HISTORIC AND DESIGN REVIEW COMMISSION

HDRC CASE NO: 2019-668
ADDRESS: 328 E HUISACHE AVE
LEGAL DESCRIPTION: NCB 3088 BLK 4 LOT 7 & E 25 FT OF 6 MF-33,H
ZONING: 1
CITY COUNCIL DIST.: Monte Vista Historic District
DISTRICT: Sue Ann Pemberton/Mainstreet Architects Inc.
APPLICANT: AMY SCHEINMAN/SCHEINMAN AMY L
OWNER: Exterior modifications, construction of a front porch
TYPE OF WORK:
APPLICATION RECEIVED: December 20, 2019
60-DAY REVIEW: February 18, 2020
CASE MANAGER: Stephanie Phillips
REQUEST:

1. Construct a new front porch.
2. Modify the existing front fenestration pattern.
3. Construct a new screened rear porch.

102 SOUTH ELEVATION
SCALE: 1/4" = 1'-0"

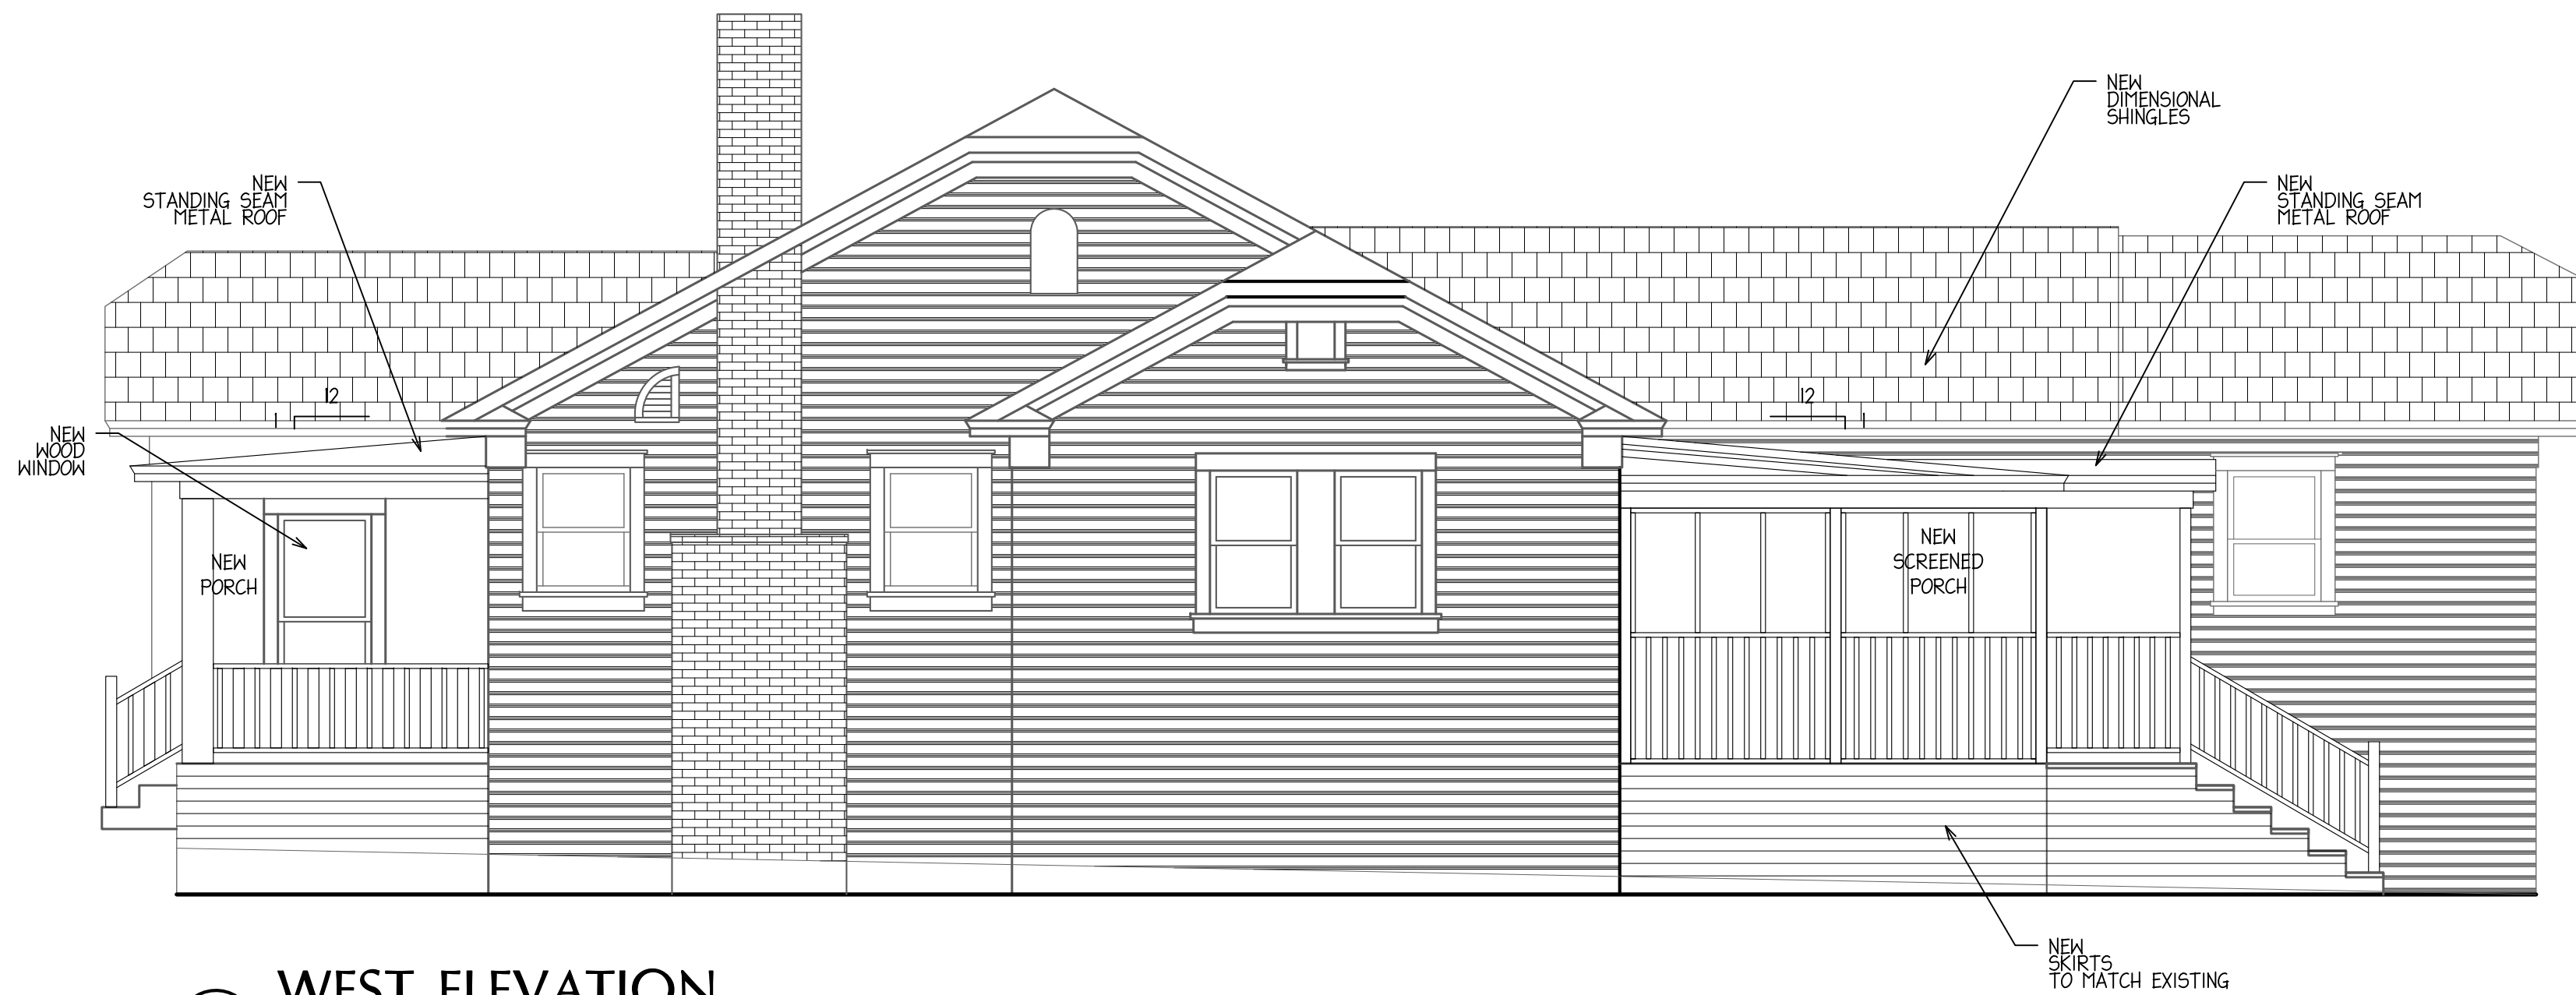
- d. FRONT PORCH – The applicant has proposed to construct a new front porch to the existing historic structure. The applicant has proposed a porch that will span the width of the inset portion of the front façade adjacent to the front gable. The porch will feature a low-sloping shed roof with simple wooden posts and railings and stairs that lead to the public right-of-way. The original entrance configuration, based on Sanborn Maps and remaining evidence, features a side-access front door located on the west side of the front gable. Based on the same evidence, the structure did not originally feature a front porch. According to the Historic Design Guidelines, porches and related entry elements should be restored to their original configuration. New elements should not detract from the original design of the structure or convey a false historic appearance. Based on the existing condition and style of the structure and the evidence provided by the applicant, staff finds that the front porch proposal is generally appropriate.

- e. FENESTRATION MODIFICATIONS – Per the submitted proposed elevation, the applicant has proposed to modify the front fenestration pattern. Two existing ganged windows will be relocated and swap locations with an existing non-original front addition. A new front door with side lites will be installed in the location of the existing ganged windows. As noted in finding b, the historic configuration of the front façade is unknown. Staff finds the proposal generally appropriate and compatible with the architectural style of the house without detracting from its character defining features or significance.

- ii. That the applicant submits a detail elevation drawing of the proposed front porch railings and columns with dimensions for staff review and approval prior to the issuance of a Certificate of Appropriateness.

101 FLOOR PLAN
SCALE: 1/4" = 1'-0"

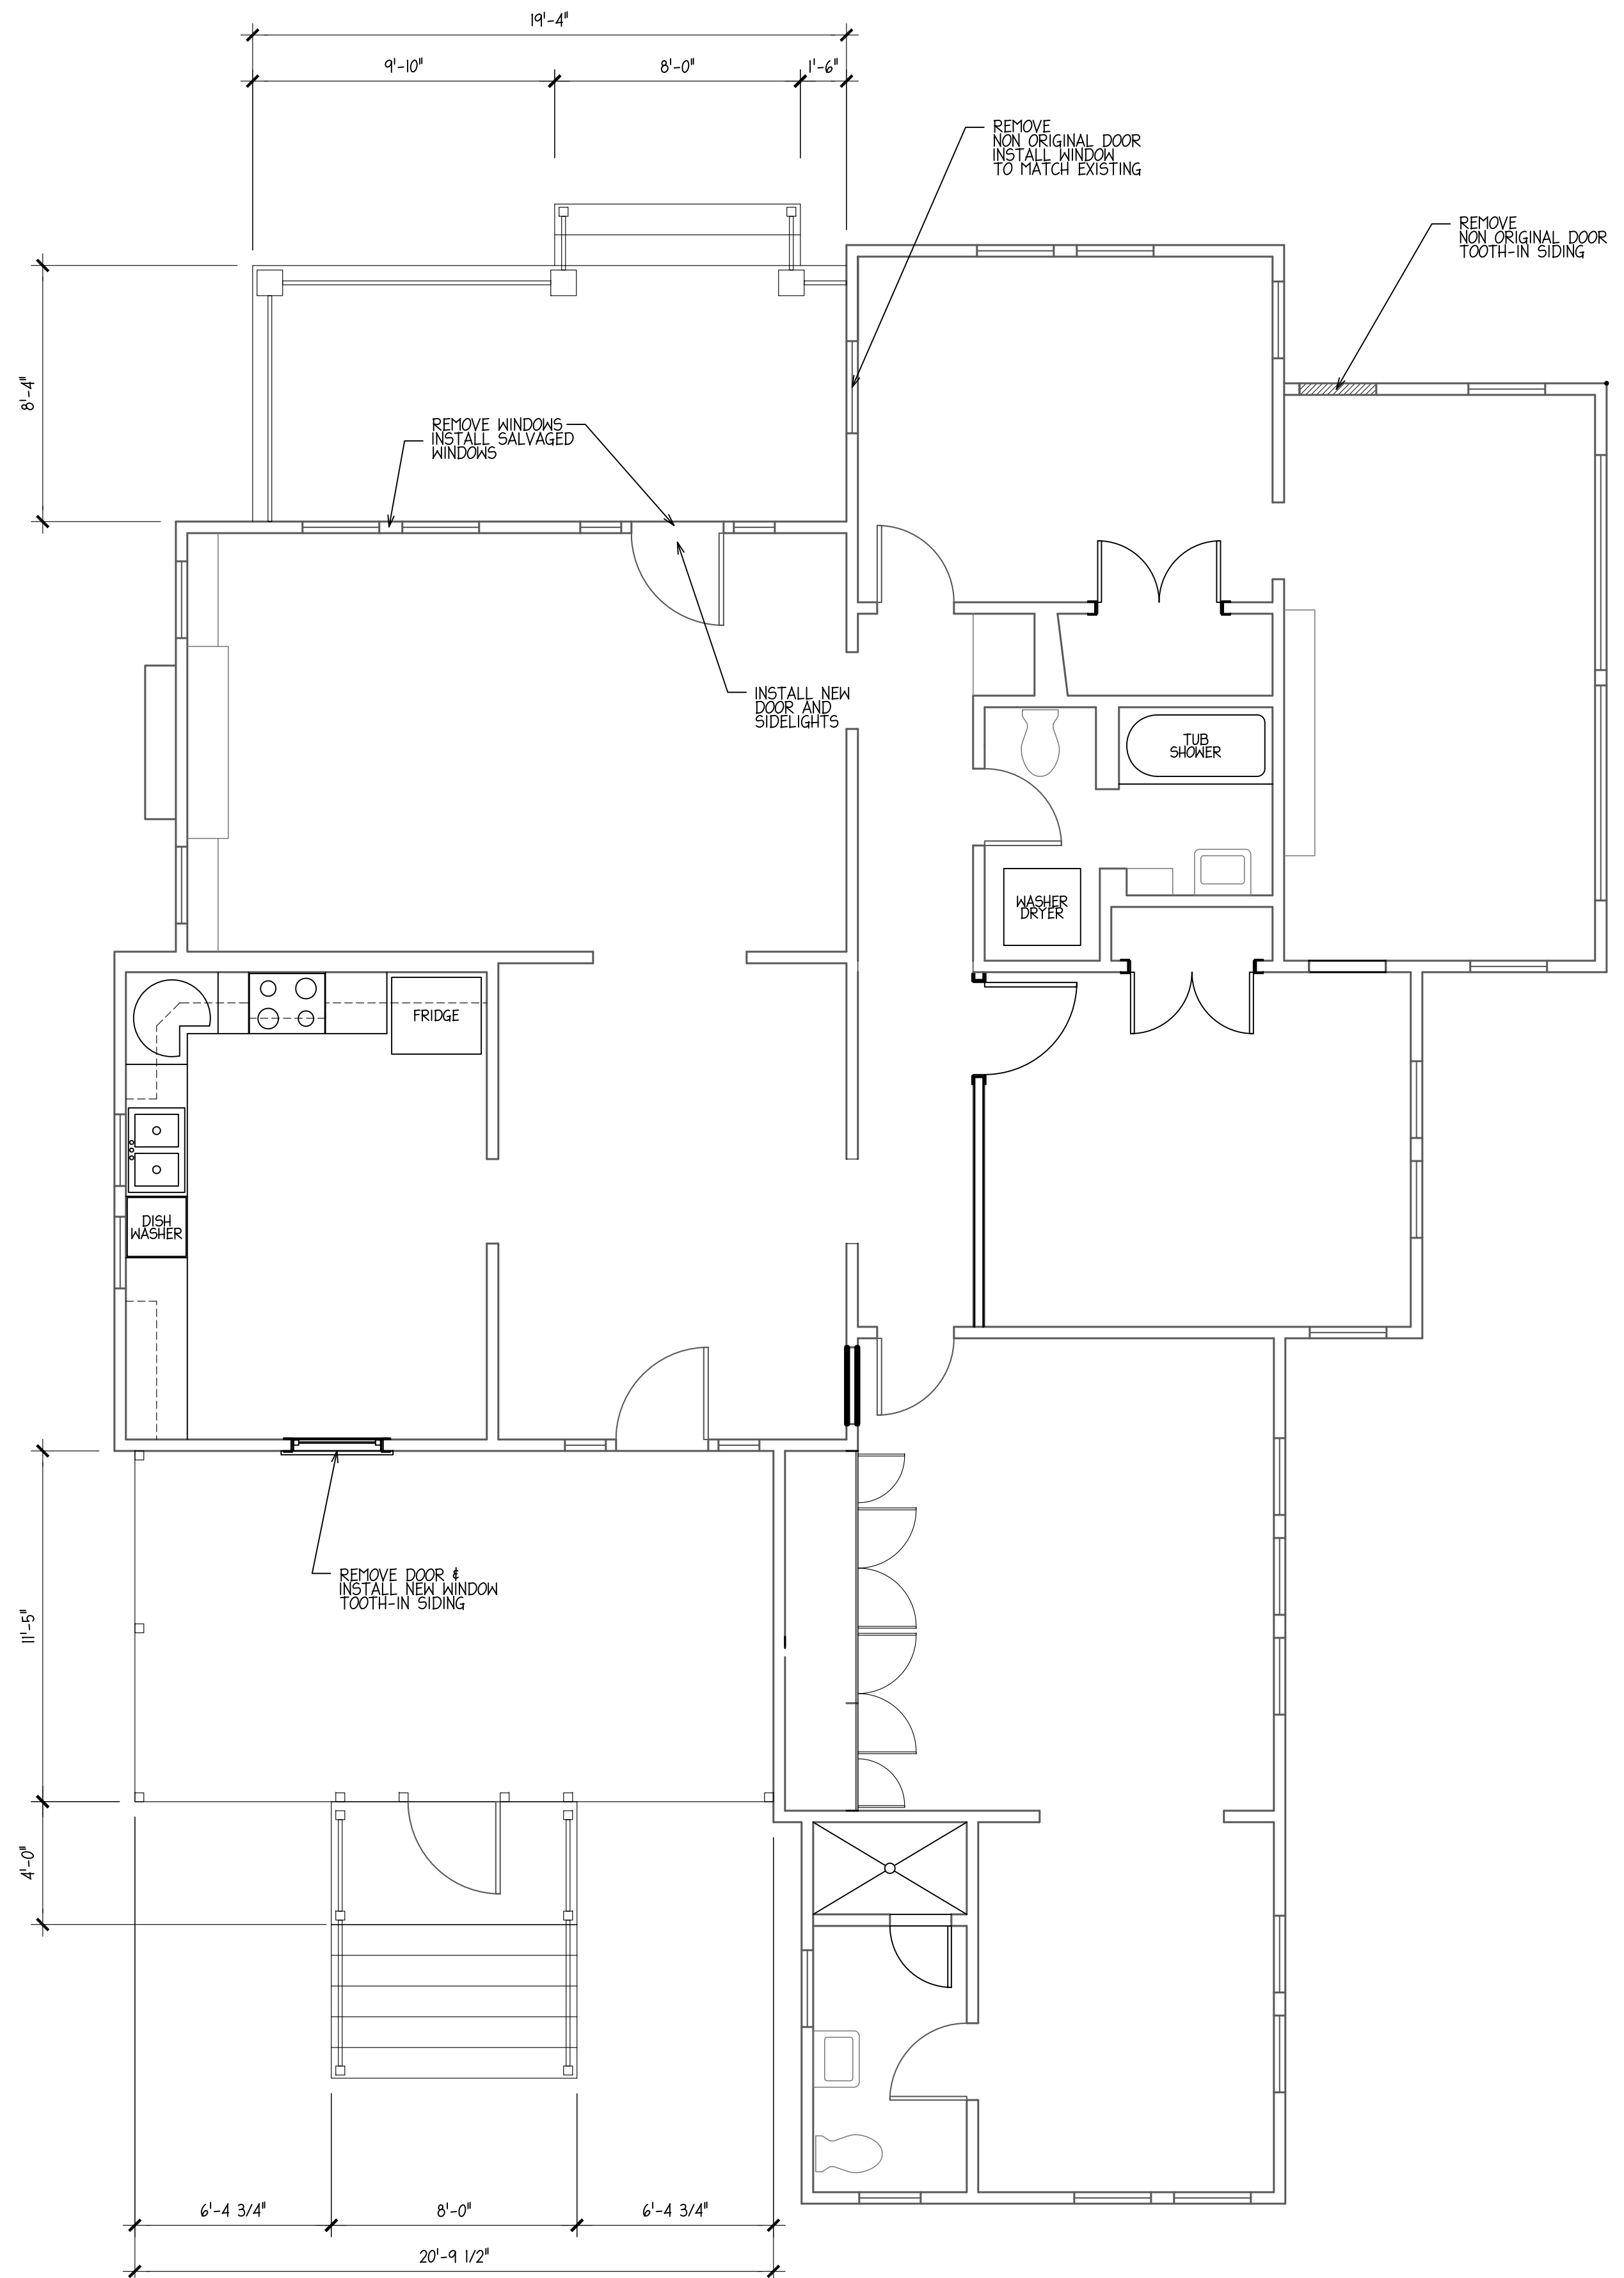
- f. REAR PORCH – The applicant has proposed to construct a new rear screened porch. The porch will measure approximately 250 square feet and will feature simple wood framing, transparent screens, and a new stairway with simple wooden posts and rails. The foundation will be clad in woodlap siding to match the existing structure and a vertical trim piece will be installed at the intersection of the two masses. According to the Historic Design Guidelines, new porch elements should be designed to be simple as to not distract from the historic character of the building. The porch will be simple in design and will not visually compete with the structure. Staff finds the proposal appropriate.
